re: Geotechnical Review – Grading Plan Review
Proposed Residential Development
3317 Navan Road - Ottawa, Ontario

date: February 27, 2024

file: PG6582-MEMO.04

PG6582 - Light Weight Fill markup - Buildings and Pavement

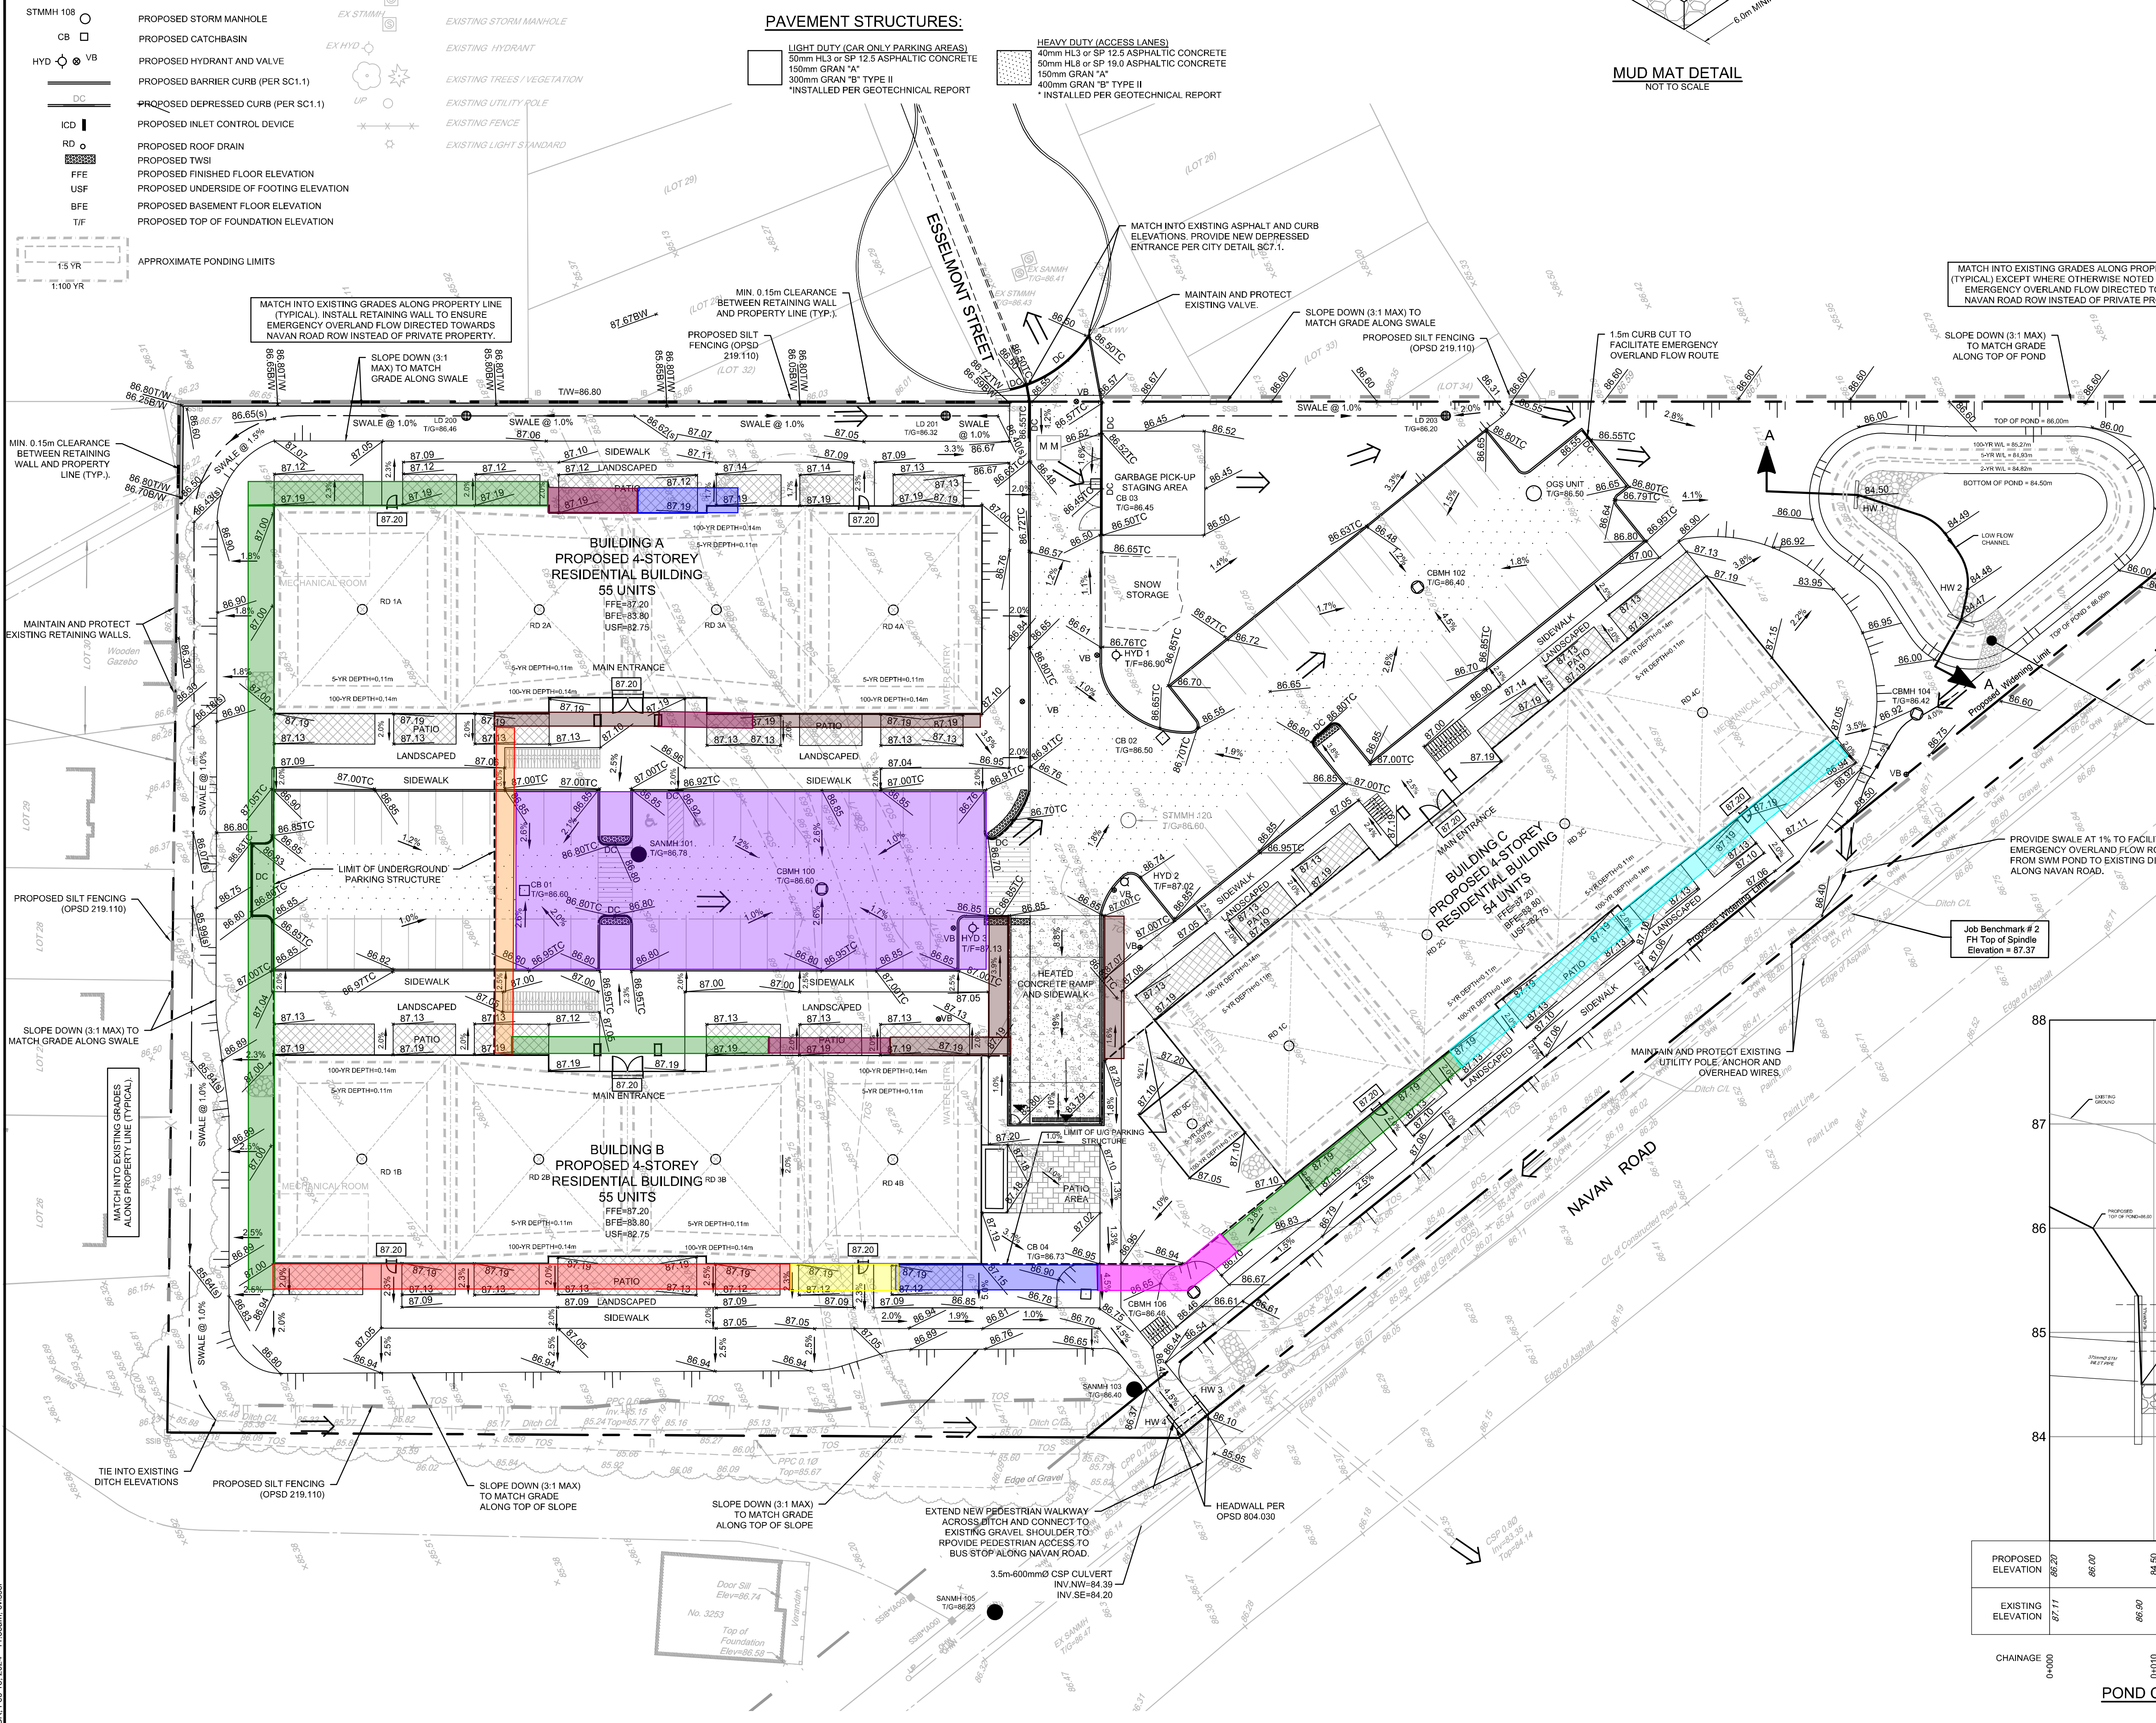
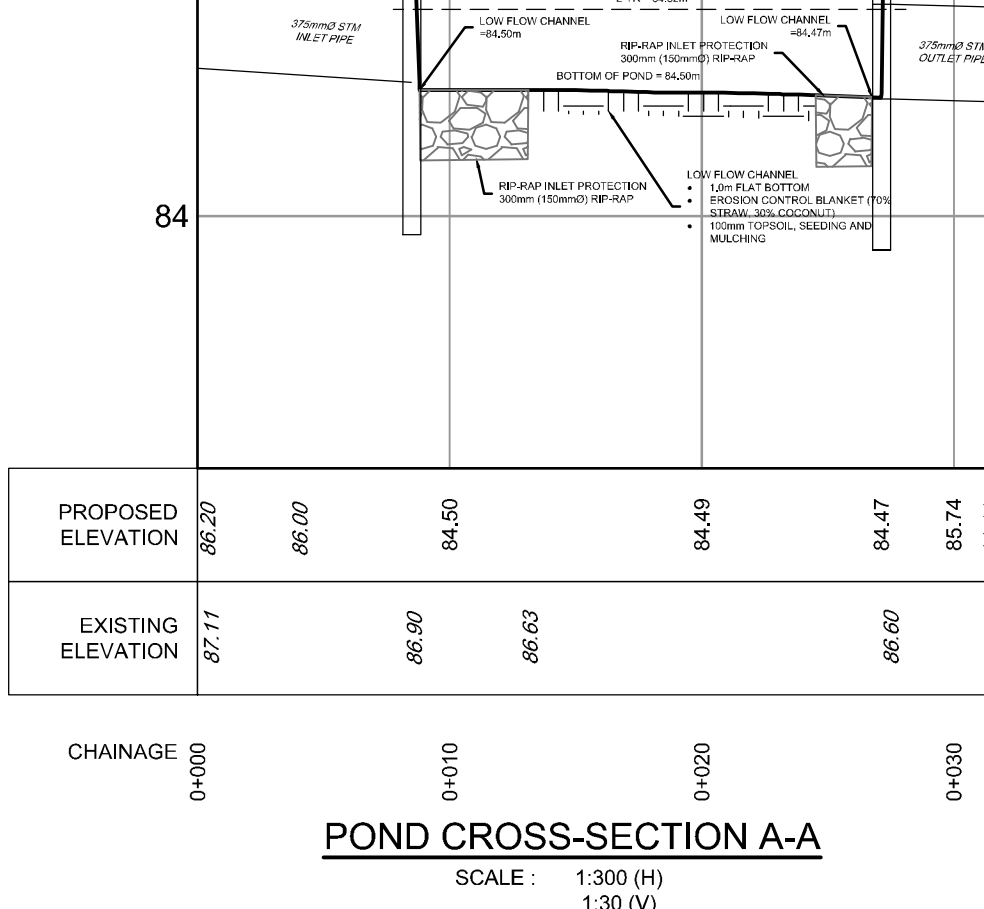
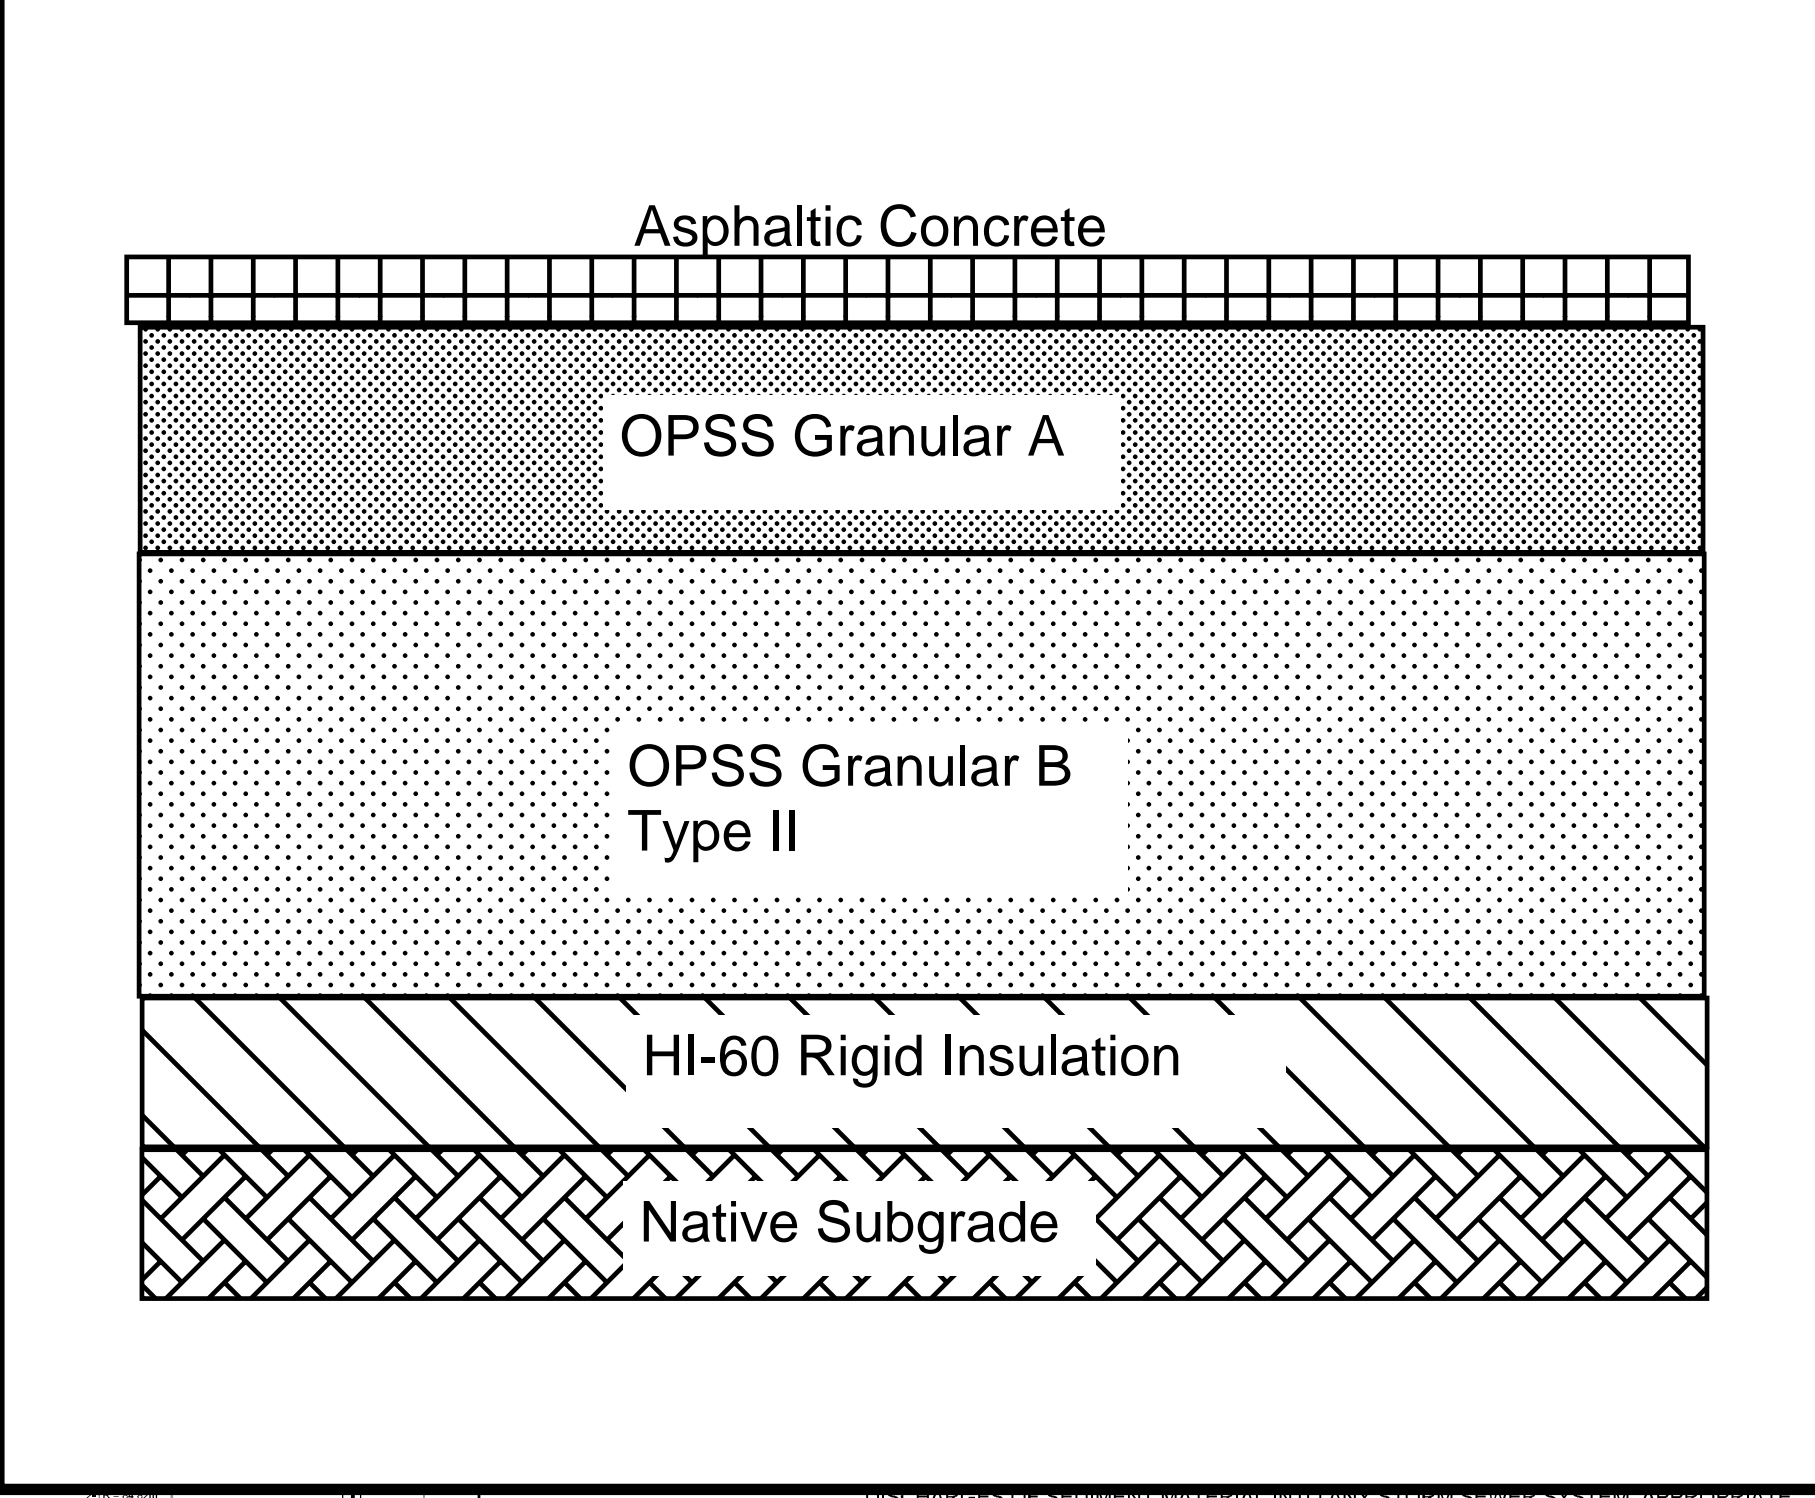
Based on our review of the above noted drawing, the proposed grading for the residential unit exceeds the permissible grade raise recommendations. Our lightweight fill recommendations are presented in the grading plan attached to the end of this report.

The LWF material should consists of EPS 15 under pavement and other parking structures and EPS 12 under soft landscaped areas. The LWF should be placed against the foundation wall, above the footing and a minimum of 600 mm below the finish surface. The LWF EPS blocks should extend a minimum of 2.4 m from the foundation wall with the thicknesses recommended in the attached marked up grading plan.

Based on our review of the grading plan, it was found that the north access lane and parking areas have exceeded the permissible grade raise. To protect proposed services and retaining wall LFW is recommended under the pavement structure.

Where LWF is required in the parking and access lanes, as indicated in attached mark ups, minimum 100 mm of HI-60 rigid insulation should be placed on the level native soil surface prior to the installation of the granular pavement base and subbase. The rigid insulation should be covered with a non-woven geotextile such as Terrafix 270 R.

Note: Parking Area between Building A and B should have HI-60 Rigid Insulation as shown in the typical car parking profile
